Project: San Angelo ISD Paging Upgrade (RFP #26-008)

Subject: Addendum 01

TECHNOLOGY ITEMS FOR ADDENDUM 01

FLOOR PLAN - LINCOLN MS

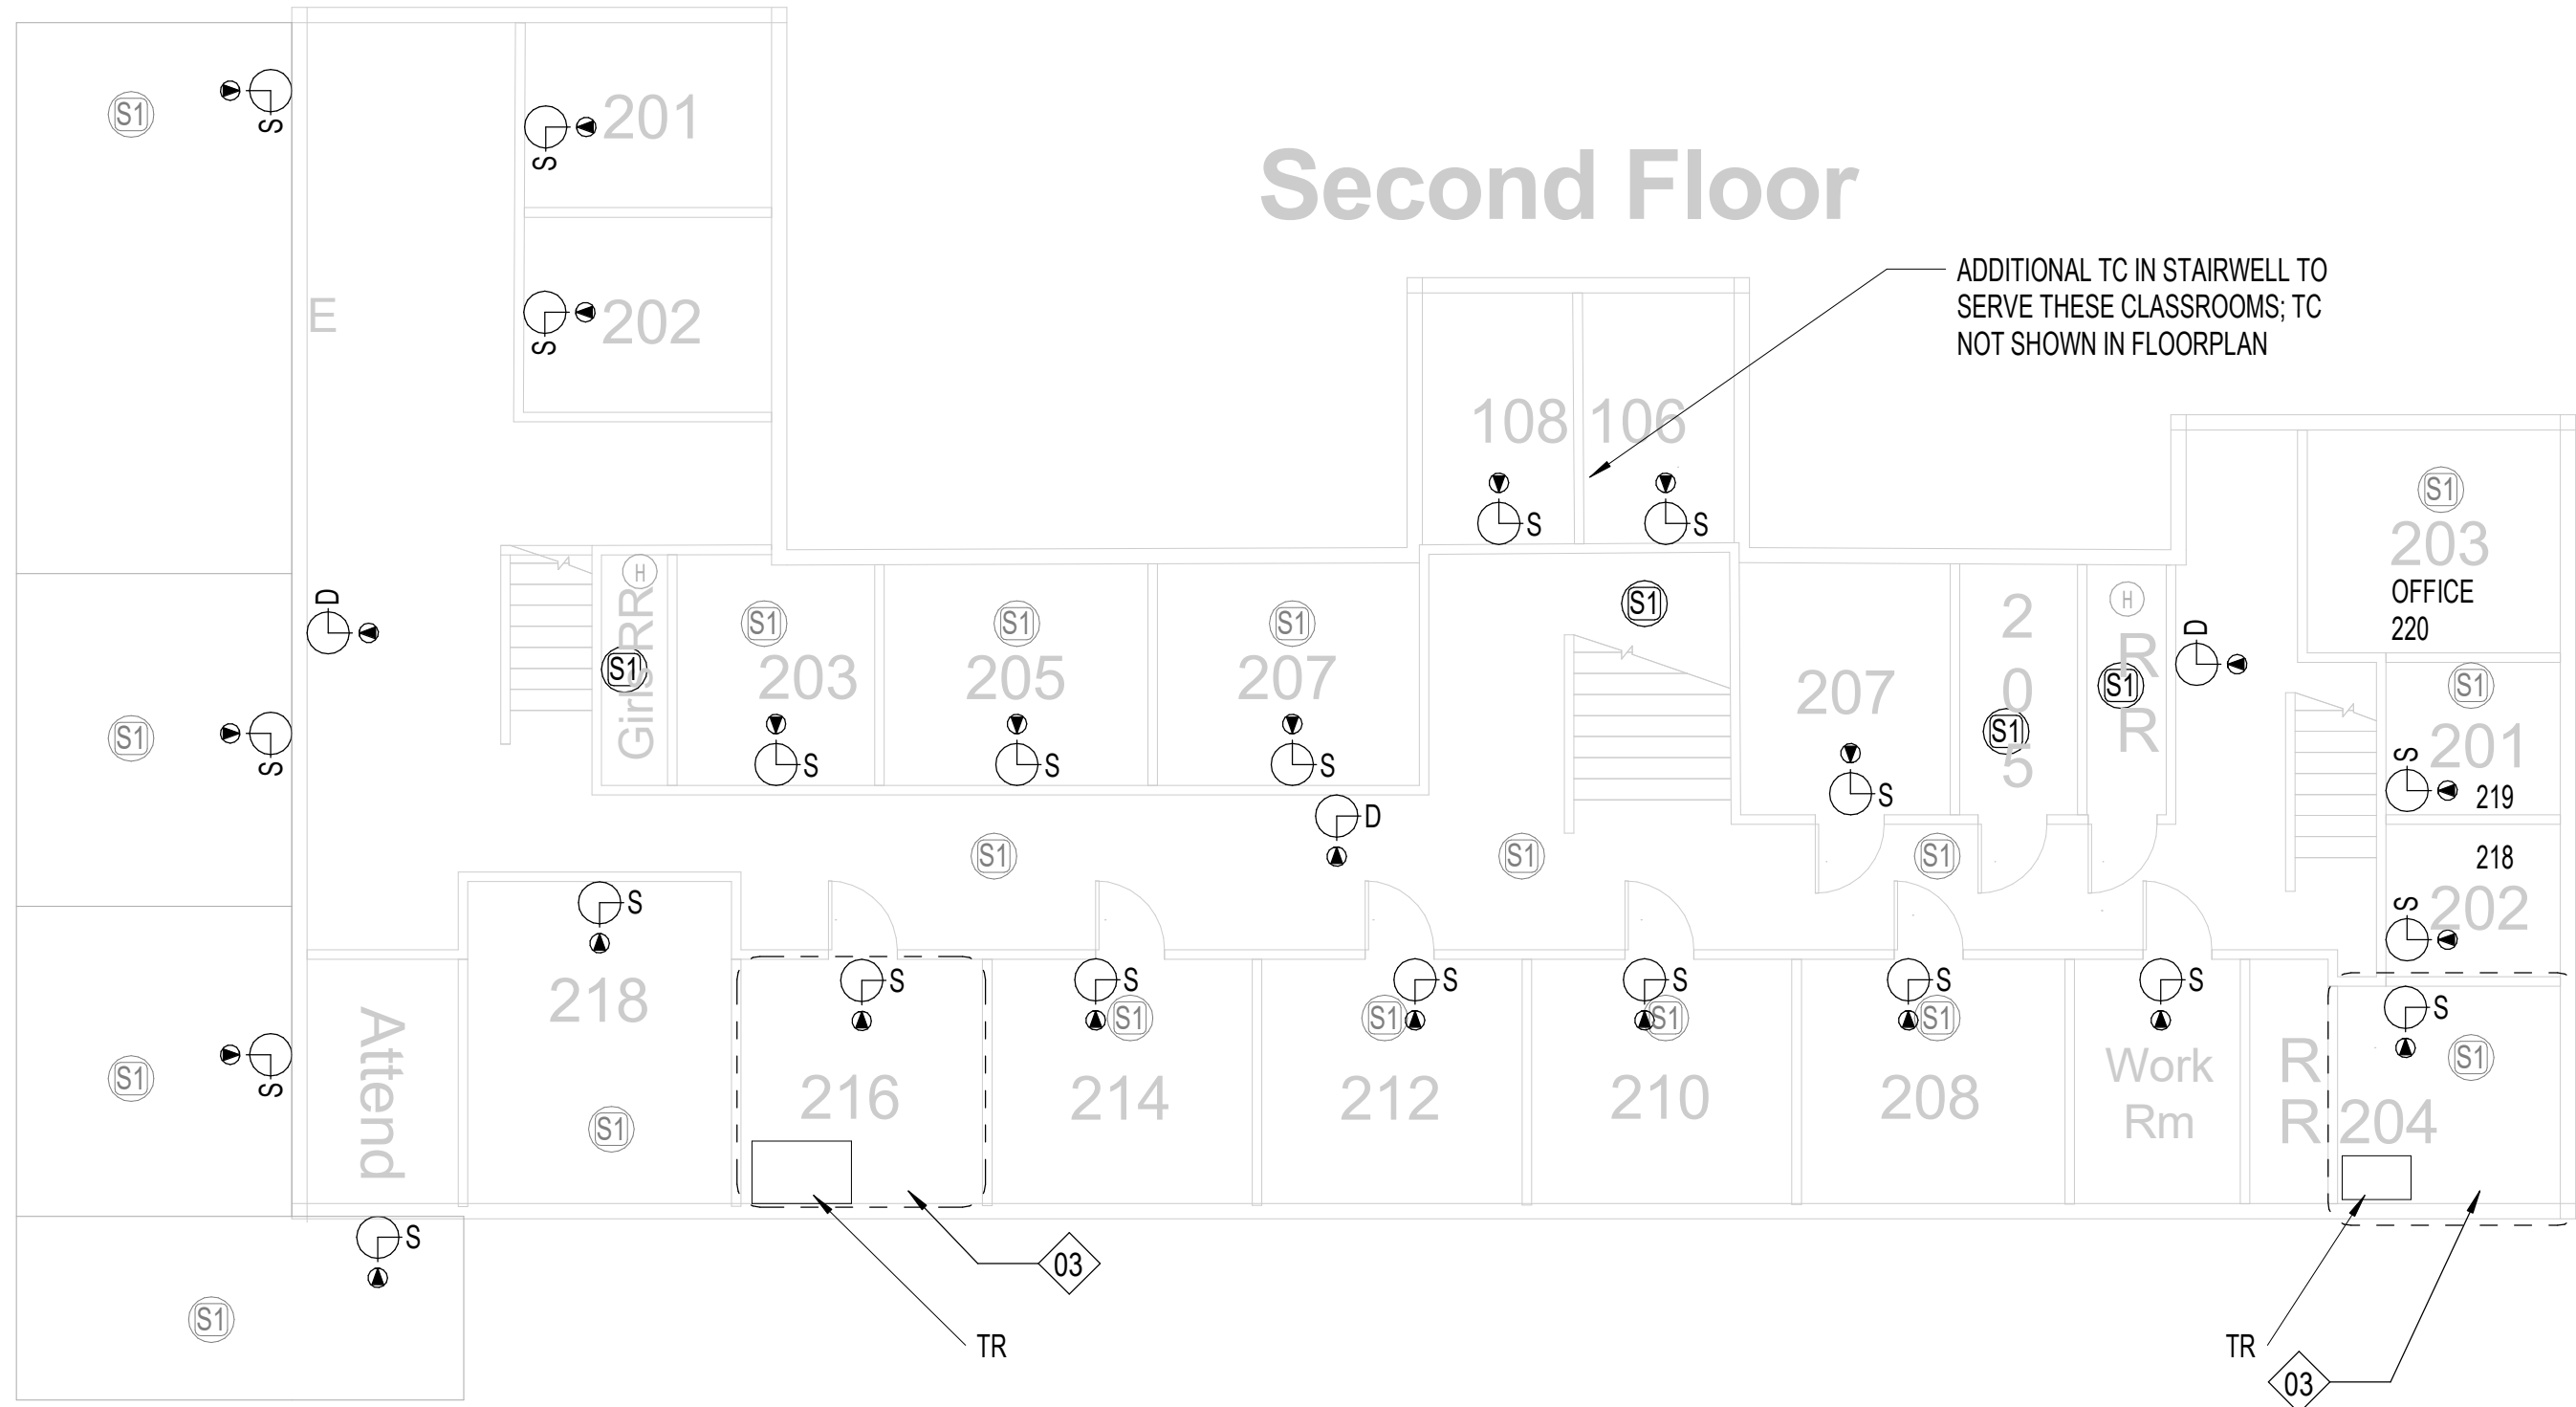
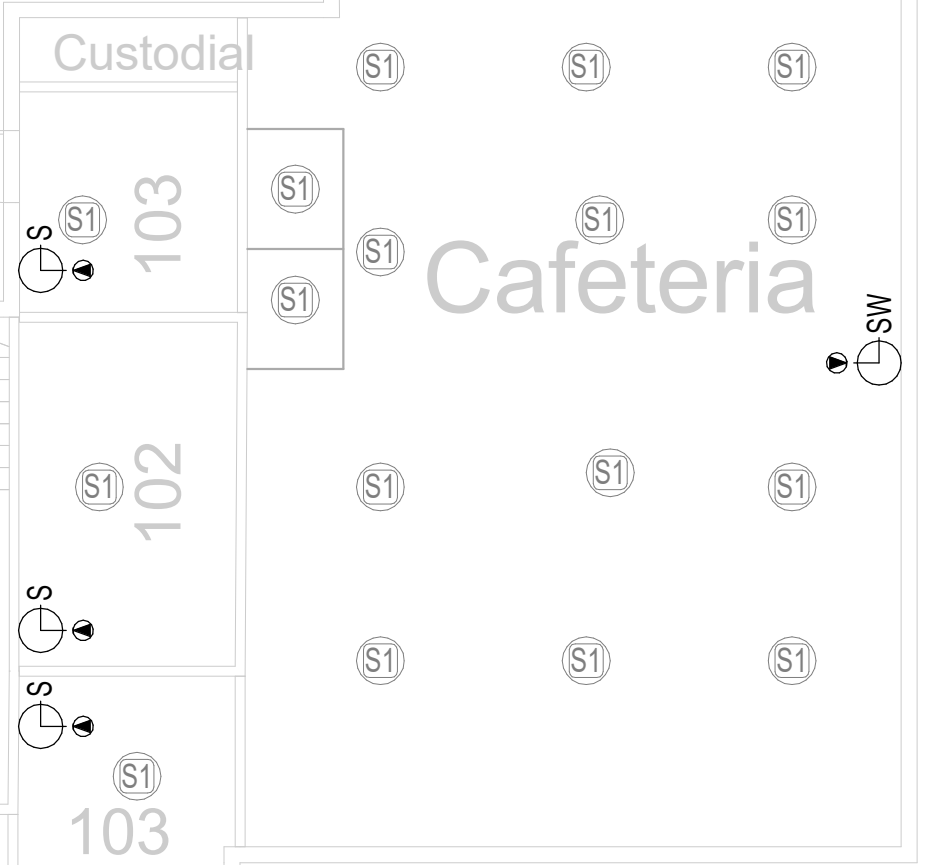
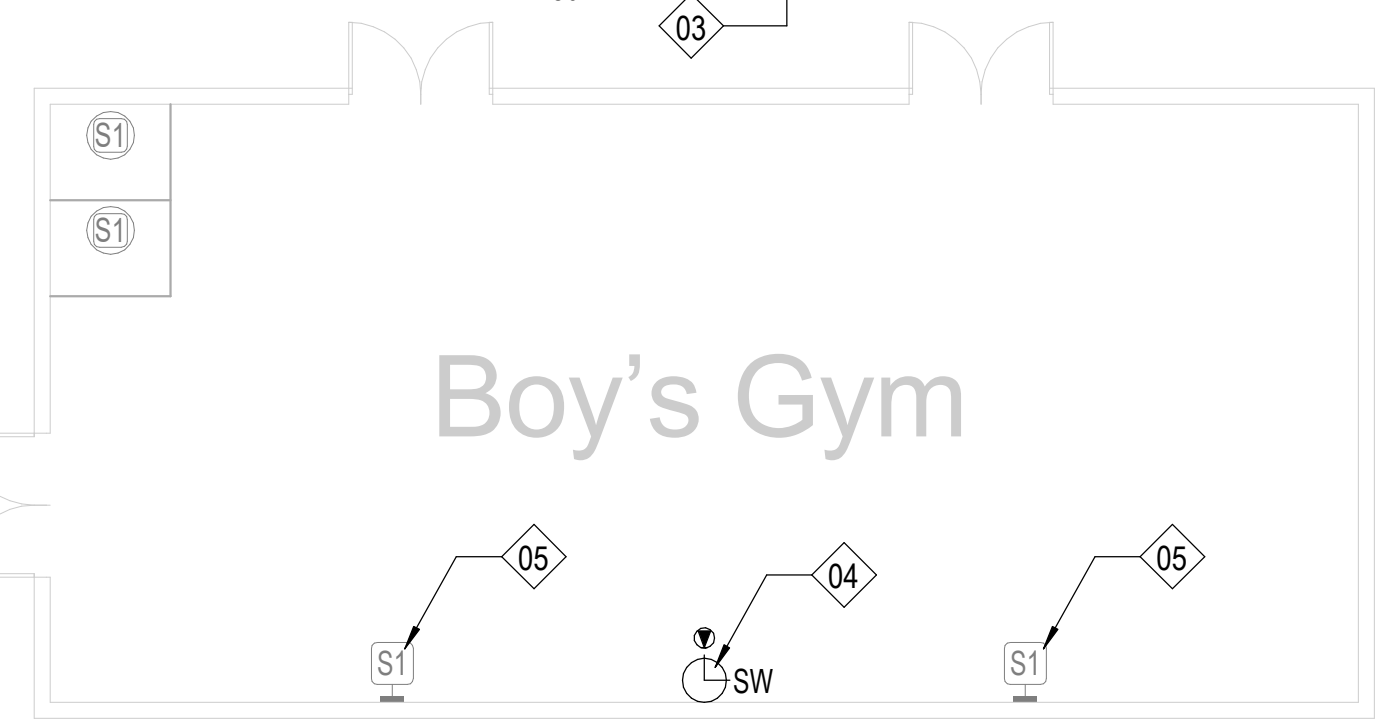
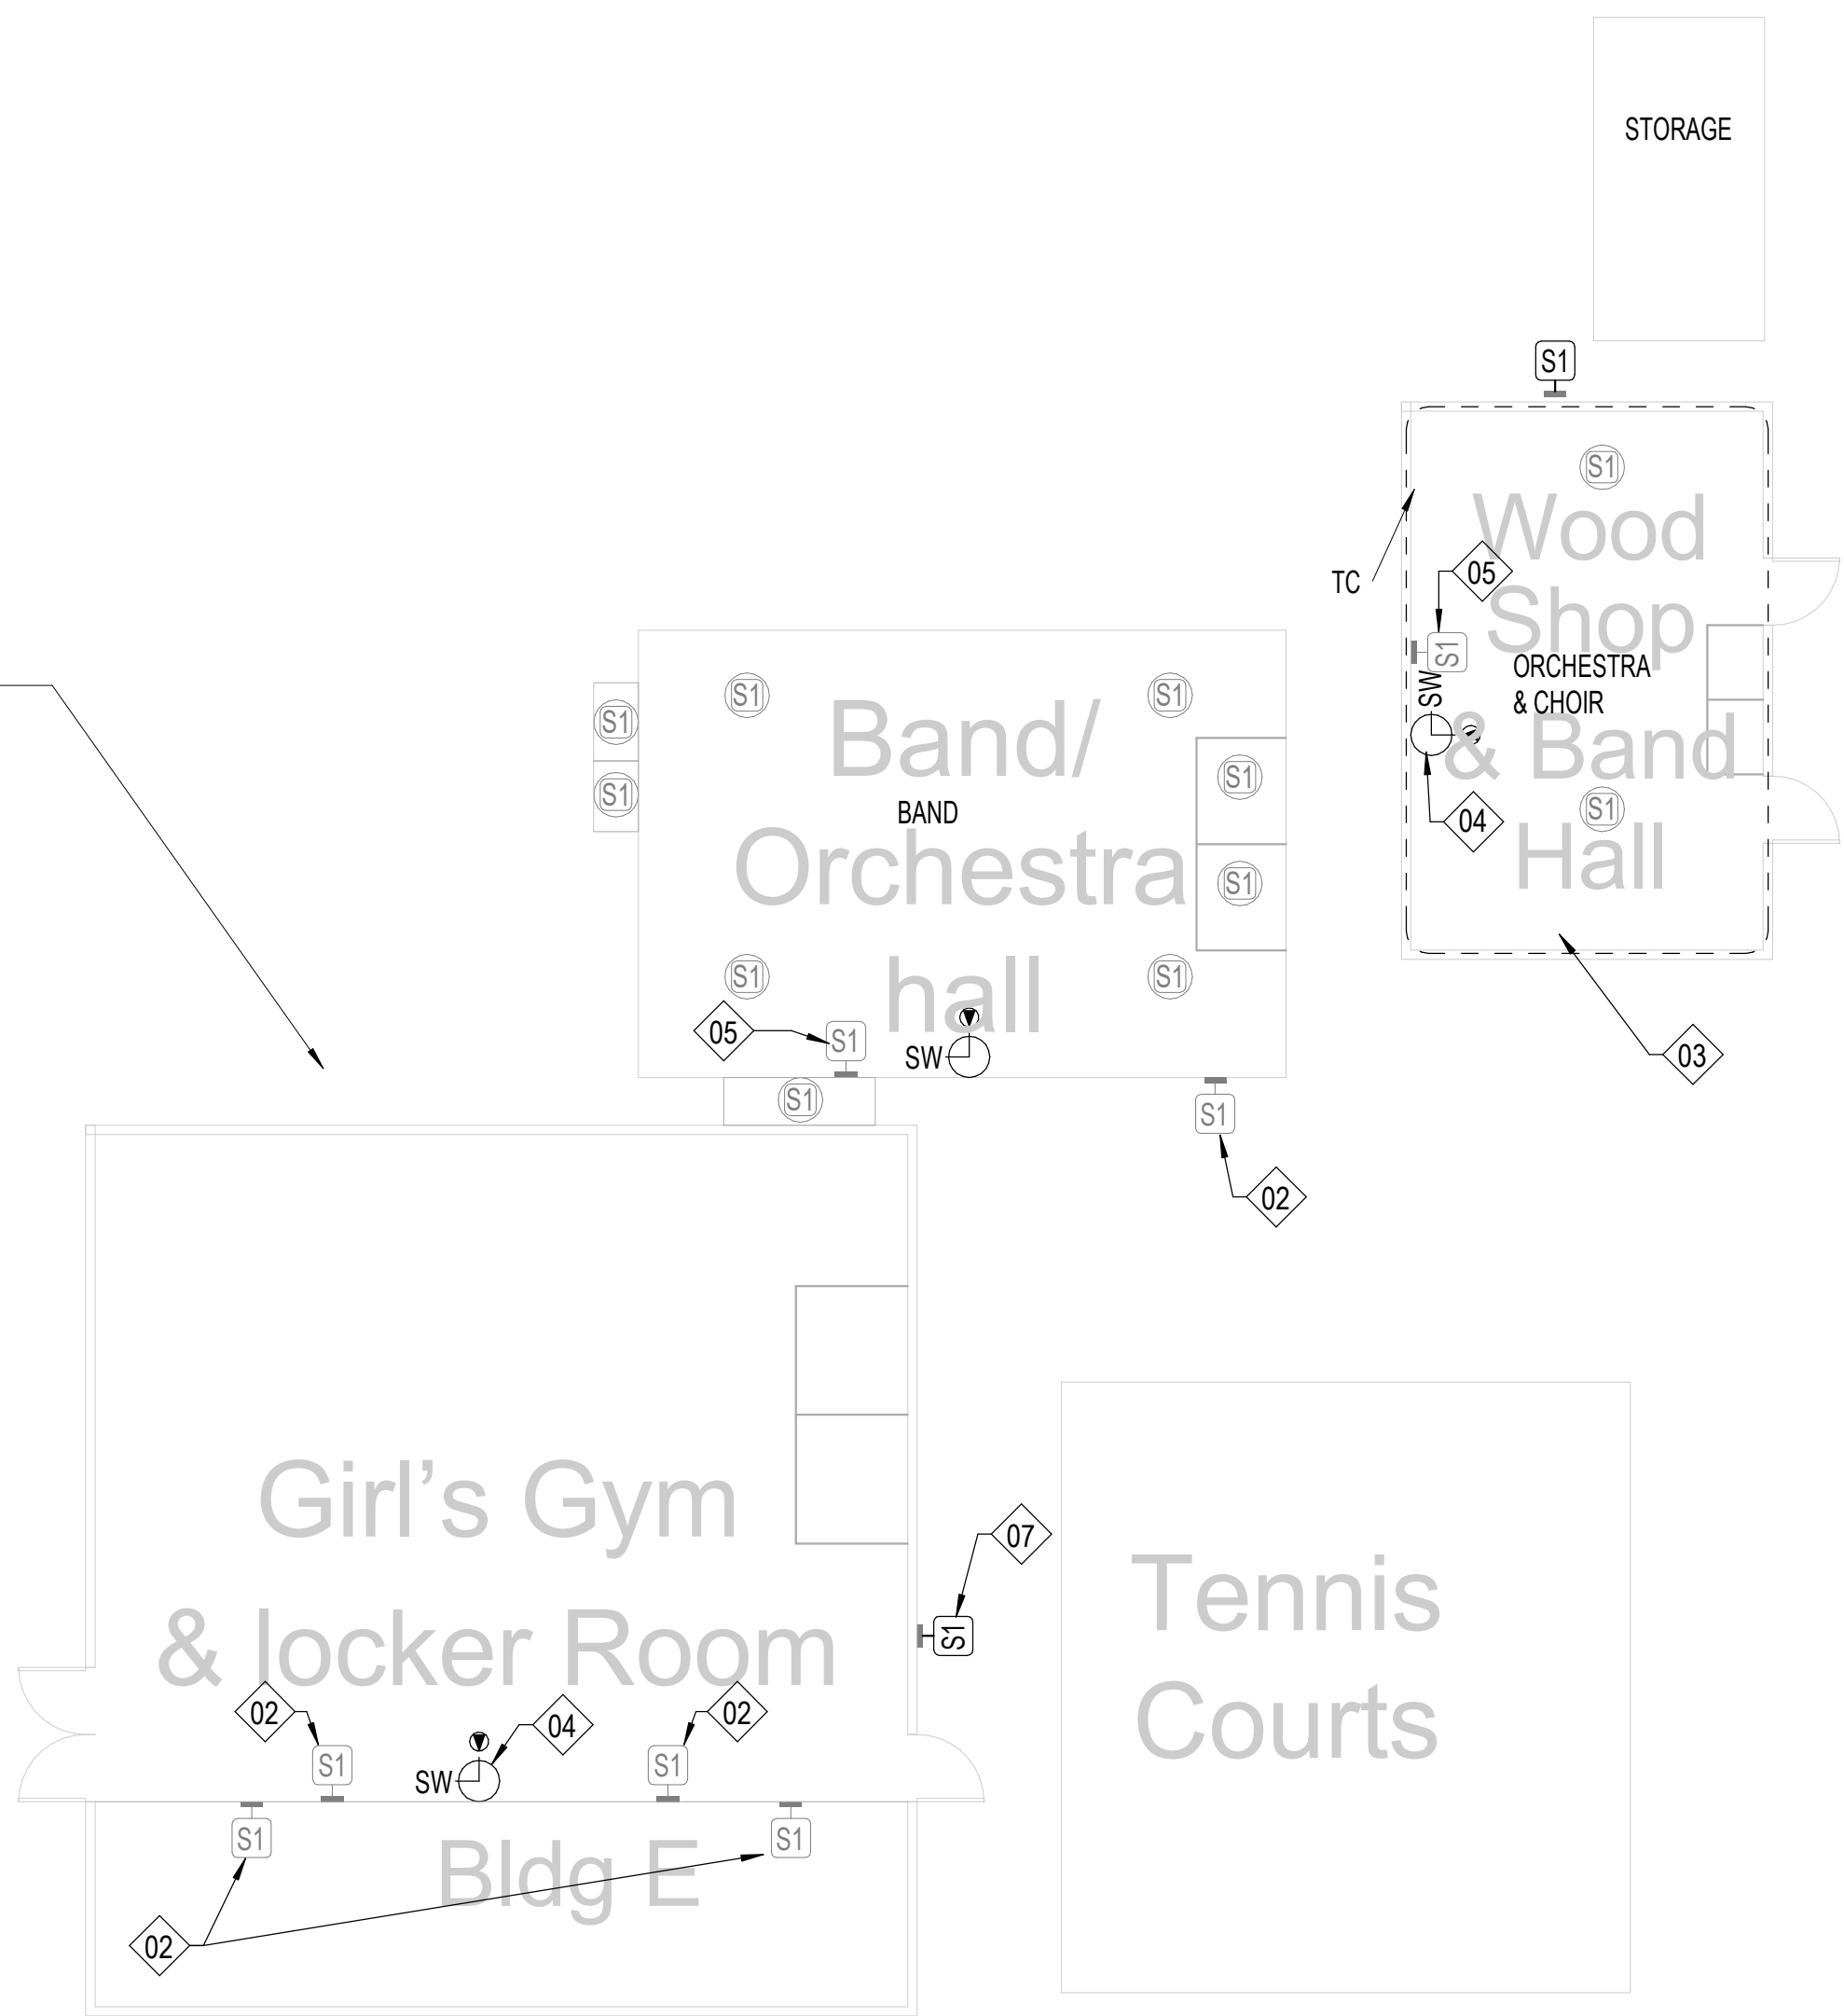
ADD No 1, Tech. Item 34: To the Drawings, Sheet T133, "FLOOR PLAN - LINCOLN ES,"

- 1) Added halftone speaker clarification to Sheet Notes.
- 2) Added paint/finish clarification to Sheet Notes.
- 3) Clarified high-ceiling lift requirement item in Sheet Notes.
- 4) Modified/consolidated Keynote 16/17.
- 5) Referenced high-ceiling sheet note in plans.
- 6) Removed address from view title.
